IMPORTANT

Land Cruiser 70, 80, 100 Series

A (1:1)

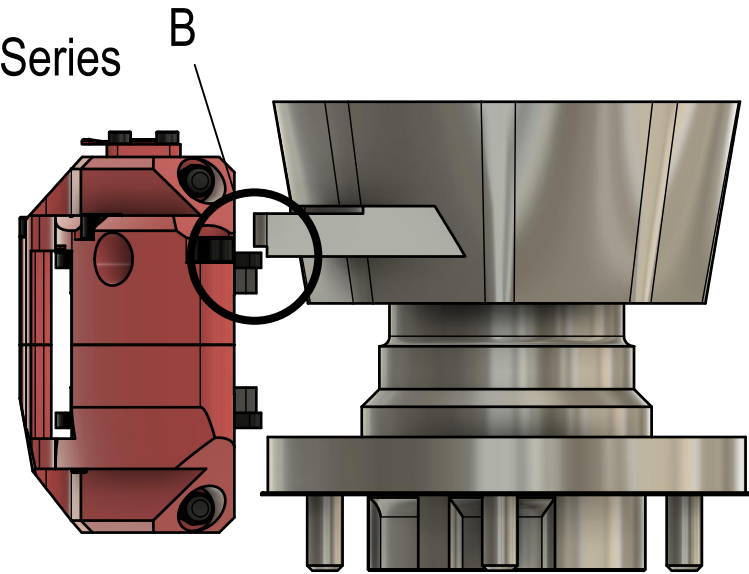
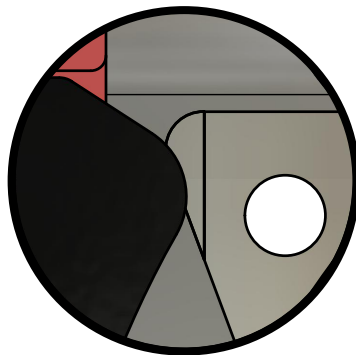
On some year models of Landcruiser the knuckles protrude further and may require slight grinding to clear the bottom of the pads in the Powerbrake caliper. Check carefully if grinding is required on **BOTH** knuckles before tightening the caliper to the bracket.

Only grind what is necessary!
